7010000-2 PROFILED THERMOPLASTIC PAVEMENT MARKINGS  
COMMENTS FROM INTERNAL/INDUSTRY REVIEW

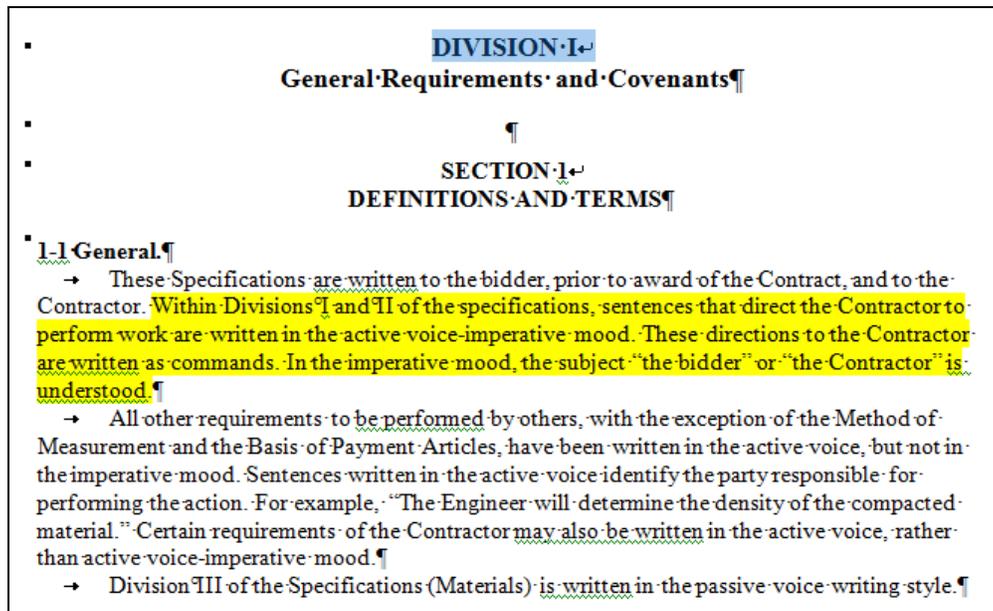
**1. From:** 701-8 Corrections for Deficiencies. Correct all deficiencies.....

**To: 701-8** Corrections for Deficiencies. Contractor to correct all deficiencies...

Response: It is understood that this direction is to the Contractor. Section 1 of the Specifications defines how Division II language is to be written. Please see excerpt below:

No changes made.
